COMMUNITY DEVELOPMENT DEPARTMENT REPORT

HEARING DATE: 9/19/2024
TO: Planning & Zoning Commission
FROM: Nick Napoli, Associate Planner
208-884-5533
nnapoli@meridiantcity.org
APPLICANT: Danielle Stehman
SUBJECT: MCU-2024-0002
Meridian Oz
LOCATION: 1475 E. Franklin Rd., in the NE 1/4 of
Section 18, T.3N., R.1E. (Parcel
#S1118110051)

Modification to the existing Conditional Use Permit (MCU) to amend bedroom counts, building elevations, and site design for a multi-family development consisting of 36 dwelling units on 2.39 acres of land in the R-40 zoning district.

D. Site Plan (date: 6/28/2024)

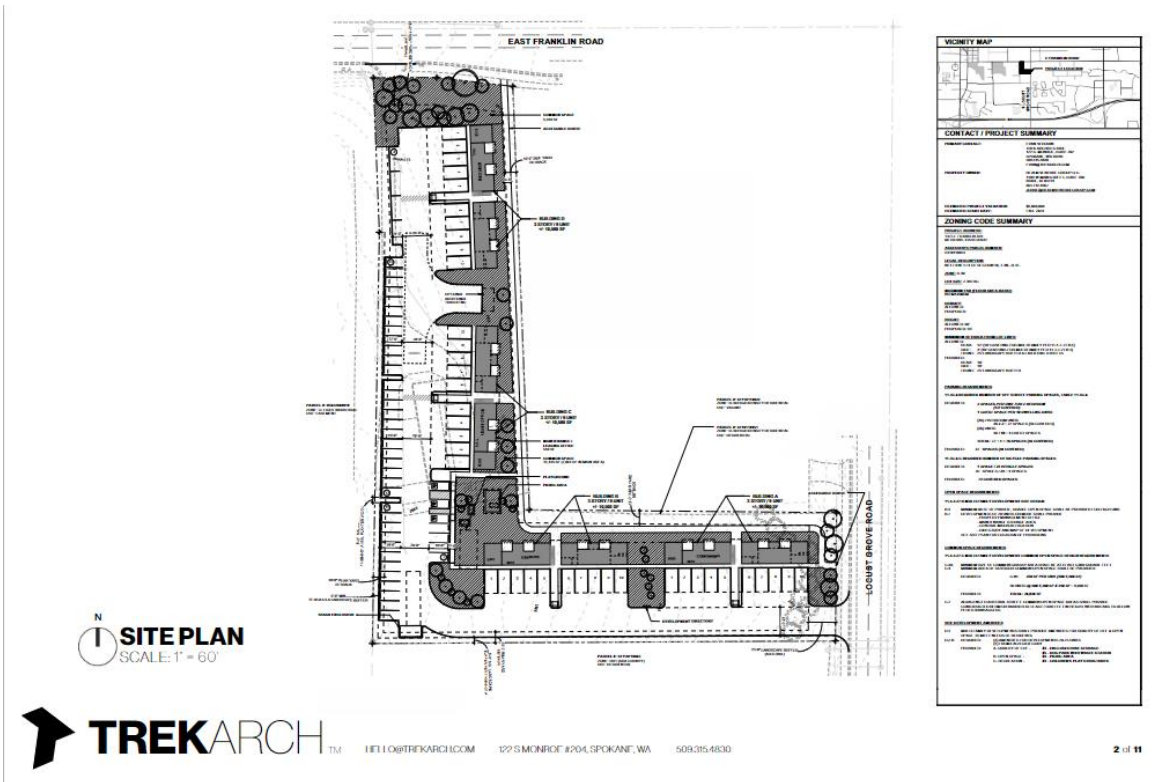
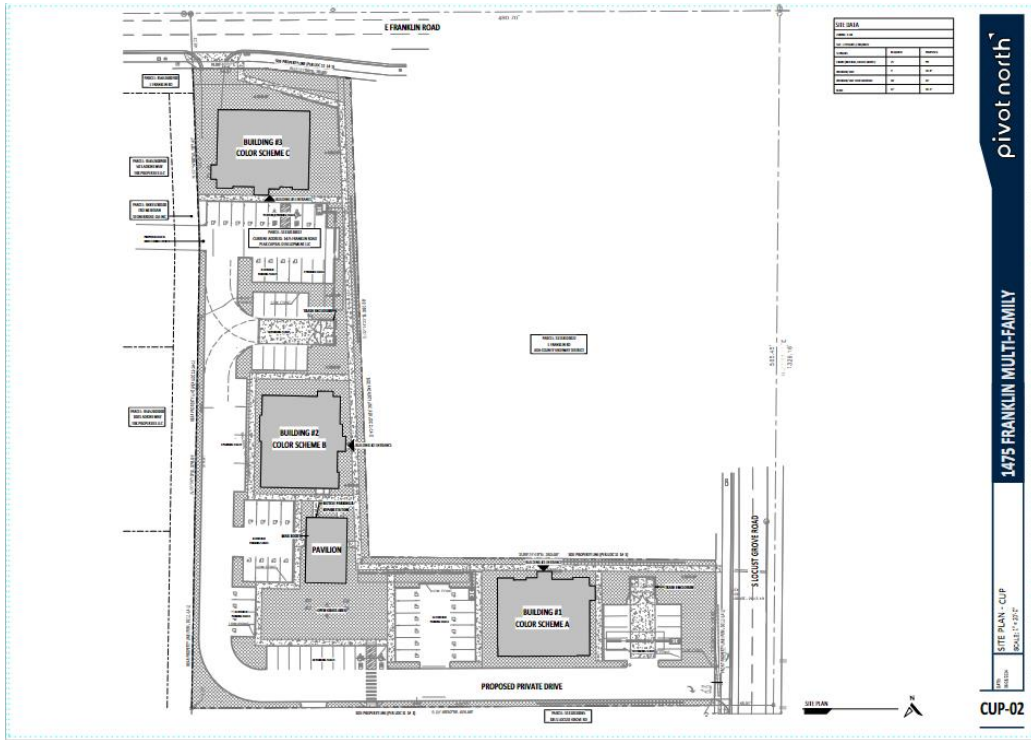
about the orientation of the building entrances as they are not visible from the drive aisle. This can cause safety issues and make it difficult for emergency services to monitor the area. Staff recommends Buildings 1 and 2 are reoriented to provide better visibility of the entrances or pedestrian lighting is provided to add additional visibility. Staff has reviewed these provisions and included comments below and conditions of approval in Section IX.

- ii. Parking lot landscaping
Landscaping is required to be provided along all parking areas per the standards listed in UDC 11-3B-8. *The proposed landscape plan does not meet the minimum requirements. The landscape plan should be revised to include a tree in every planter island, if this is not feasible due to utility easements, alternative compliance shall be applied for with the certificate of zoning compliance submittal.*

and driveway, including a pedestrian walkway, to facilitate future interconnectivity with the property to the south, in accordance with UDC 11-3A-3A.2. Staff recommends this cross-access is moved to align with the parking curb cuts closest to Locust Grove.

h. Move the proposed cross access on the south portion of the site closer to Locust Grove to align with the parking area to the east of Building 1. Record a cross-access/ingress-egress easement with a pedestrian walkway to the property to the south for future interconnectivity in accordance with UDC 11-3A-3A.2. A copy of the recorded easement shall be submitted to the Planning Division prior to issuance of the first Certificate of Occupancy within the development.

n. Depict wheel stops in all of the parking spaces abutting a sidewalk or widen sidewalks to 7 feet to prevent vehicle overhang onto the adjacent walkway.

p. Widen the parking drive aisles to be a minimum of 25 feet.

r. Reorient buildings 1 and 2 to provide better visibility of the entrances for safety purposes or provide pedestrian lighting along the pathway to the entrances.

E. Landscape Plan (date: 7/2/2024)

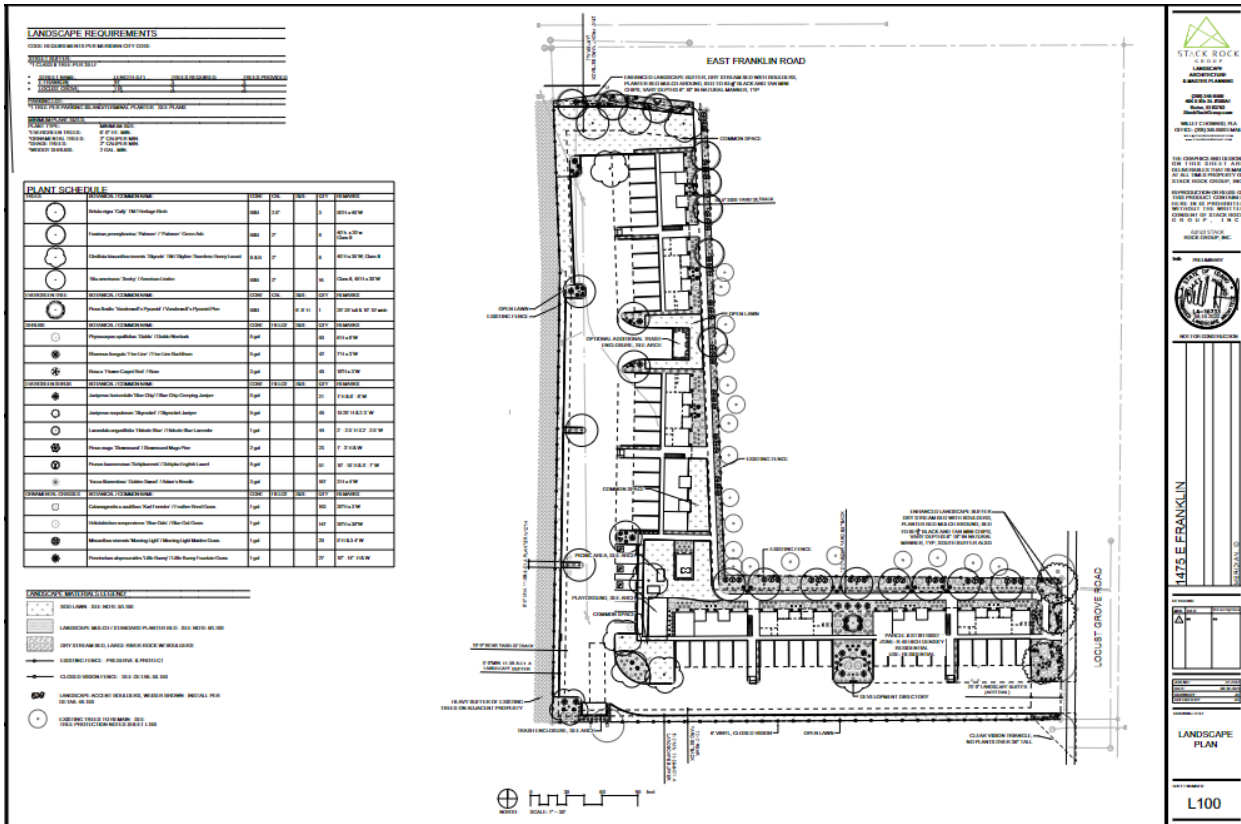
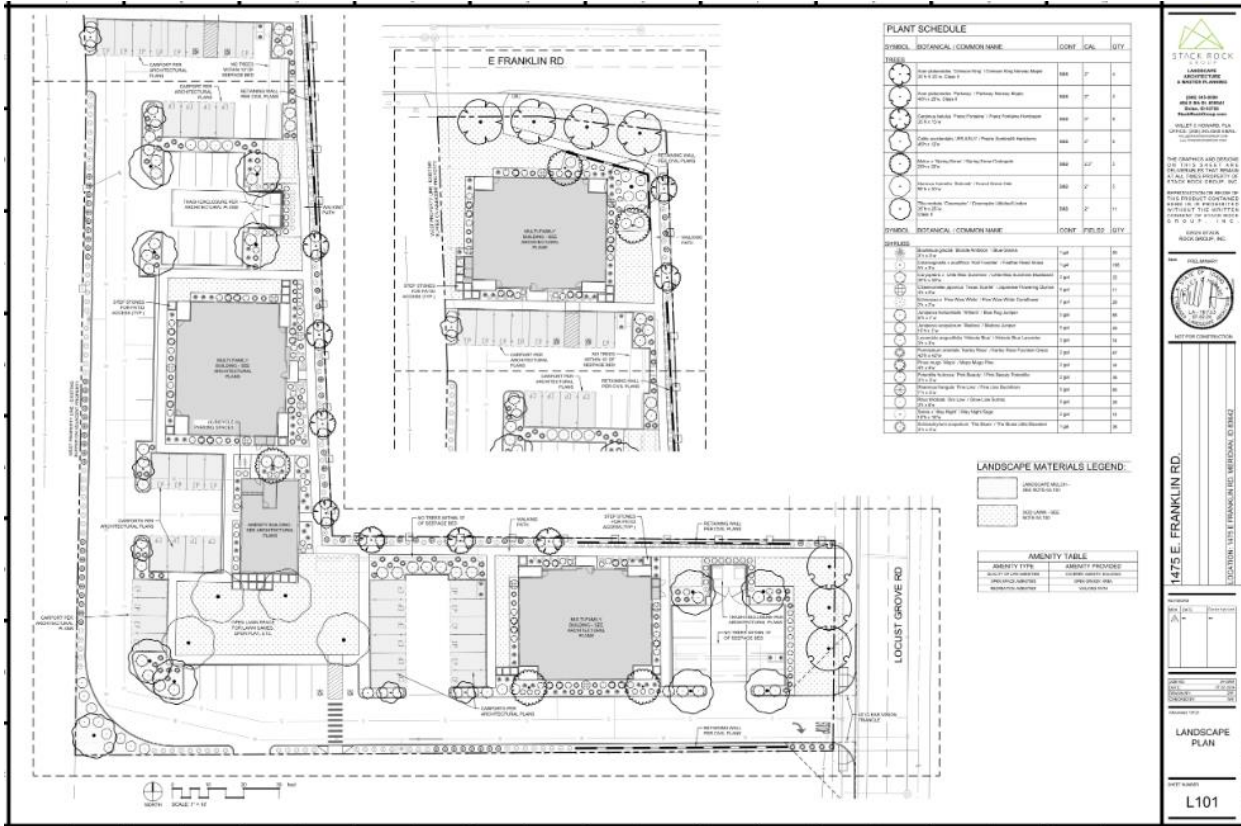
- iii. Landscape buffers to adjoining uses
The perimeter buffers along the west and south boundaries are required to be landscaped per the standards listed in UDC 11-3B-8C.1 for parking lots. A minimum of one (1) Class II or III tree is required every 35 linear feet along with shrubs and vegetative groundcover. *The landscape plan should be revised to include trees and calculations that demonstrate compliance with the standard on the Southern property boundary.*

- vi. Pathway landscaping
Landscaping is required to be provided along all pathways per the standards listed in UDC 11-3B-12C; *The proposed landscape plan does not meet all of these requirements. A tree is required on either side of the pathway every 100 linear feet. This is not being met for a portion of the pathway on the east portion of the site. A revised landscape plan shall be submitted with the certificate of zoning compliance.*

There are no multi-use pathways designated on the Pathways Master Plan for this site. An internal 6-foot wide pedestrian walkway is proposed along the east perimeter boundary of the development adjacent to the existing ACHD storm drainage pond at the corner of Franklin and Locust Grove Roads which could be reduced to 5-feet in width. Landscaping should be provided along the internal pathway in accord with the standards listed in UDC 11-3B-12C; the landscape plan should be revised accordingly.

- d. Depict landscaping within the 5-feet on both sides of the internal pathway in accord with the standards listed in UDC 11-3B-12C. Include calculations to demonstrate compliance in the Landscape Requirements table.

- f. Depict trees and shrubs along with vegetative groundcover within the perimeter buffers adjacent to parking or other vehicular use areas along the west and south boundaries of

the site in accordance with the standards listed in UDC 11-3B-8C.1. Include calculations to demonstrate compliance in the Landscape Requirements table.

o. Depict a tree in every planter island, if this is not feasible due to utility easements, alternative compliance shall be applied for with the certificate of zoning compliance submittal.
